Re: Flint Hills Resources Corpus Christi, LLC - West Refinery
PSD Greenhouse Gas Permit Application
Domestic Crude Project
Response to Information Request

RESPONSES TO INFORMATION REQUEST

Revised Process Flow Diagrams

START-UP/SHUTDOWN/MAINTENANCE ACTIVITIES FROM DOMESTIC CRUDE PROJECT PROCESS FLOW DIAGRAM

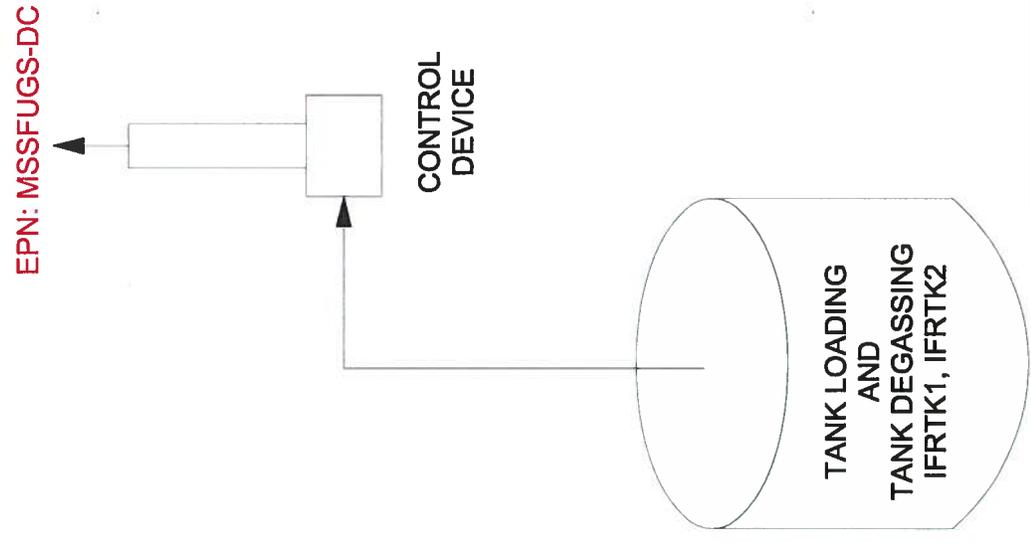
1. **The following EPN was not shown on the initial process flow diagram submitted in the application or the revised process flow diagram submitted in the response. Please supplement process flow diagrams indicating the following emission sources:**

MSSFUGS-DC (New)

IFRTK1 (New)

IFRTK2 (New)

A new process flow diagram for MSSFUGS-DC is provided in Attachment A. As mentioned in the original submittal and FHR's May 16, 2013 response, Tanks IFRTK1 and IFRTK2 will not result in GHG emissions during normal operation due to the types of products they will be storing. However, the tanks will result in GHG emissions during maintenance because emissions generated during tank maintenance activities will be controlled using combustion sources. Therefore, these two new tanks have been included on the new process flow diagram for MSSFUGS-DC.

PROCESS FLOW DIAGRAM COOLING TOWERS

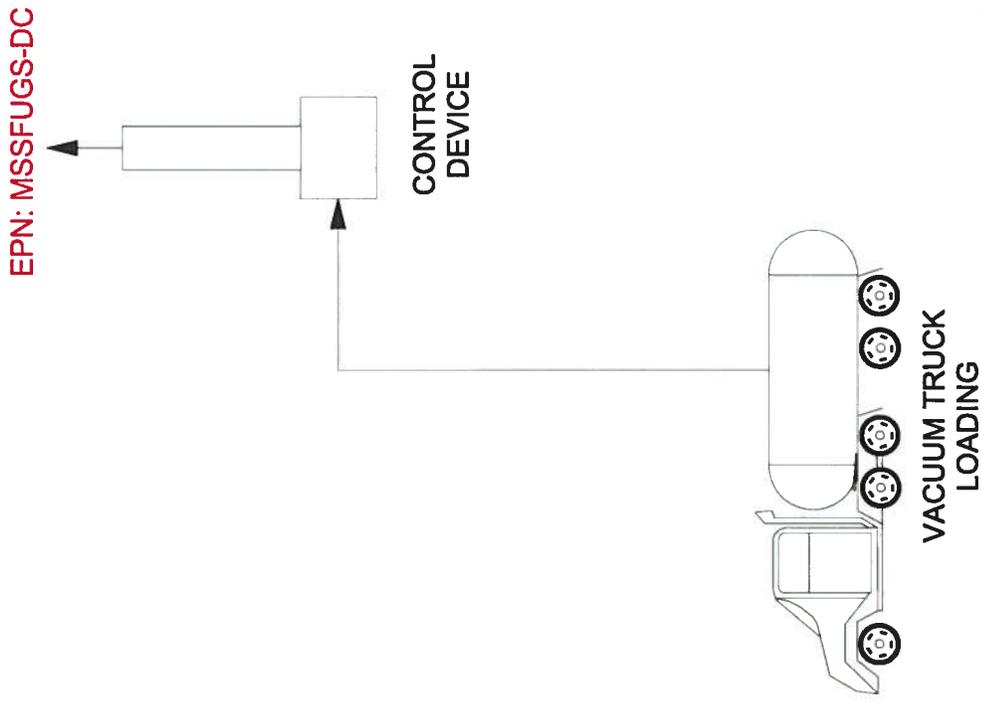
2. **On page 105 of the initial process flow diagram, one block is used to depict the cooling tower fugitives. However, two cooling towers are listed as part of this project:**

F-S-201 Mid-Plant Cooling Tower (Modified)

F-S-202 Mid-Plant Cooling Tower No.2 (New)

Please provide supplemental information to the process flow diagram to show both cooling towers

Both cooling towers now appear on the revised process flow diagram provided in Attachment A.

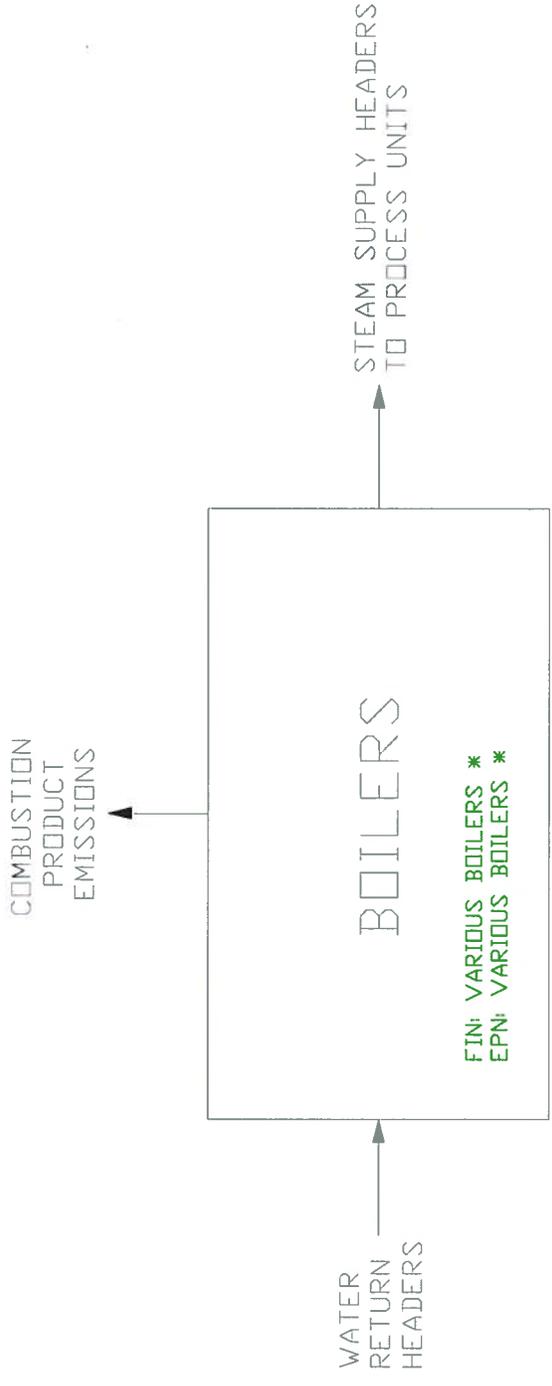
3. **On page 3 of the response provided by FHR, it is stated that seven boilers potentially will be affected by the project. These boilers could potentially see an increase in utilization as a result of the project, but the total incremental increase from all of the boilers will not be more than 96 MMBtu/hr. Therefore, the seven boilers have been grouped together into an emission source called "Various Boilers" and as so represented on the process flow diagram. Please provide written confirmation that the project will not cause a change in method of operation and permit limit for *each* of the boilers that comprise the "Various Boilers."**

There was a typo on Page 3 of the initial response and on the revised process flow diagram for the boilers provided in FHR's May 16, 2013 response. There are six boilers, not seven, potentially affected by the project. A revised process flow diagram for the boilers is provided in Attachment A.

FHR confirms that the project will not cause a change in method of operation for any of the boilers. As represented in the permit application, the total incremental increase in duty from the six boilers combined will not be more than 96 MMBtu/hr. Additionally, although FHR expects that this increase in duty will be distributed among multiple boilers, we have confirmed that an increase in duty of 96 MMBtu/hr above baseline (annual average for 2011-2012) operations at any one of the six boilers would not result in an exceedance of any boiler's permitted emission rates.

* There are six boilers potentially affected by the project. Any of these boilers could potentially see an increase in utilization as a result of the project. Therefore, the six boilers have been grouped together into an emission source called Various boilers. Each of the boilers has their own vent stack.
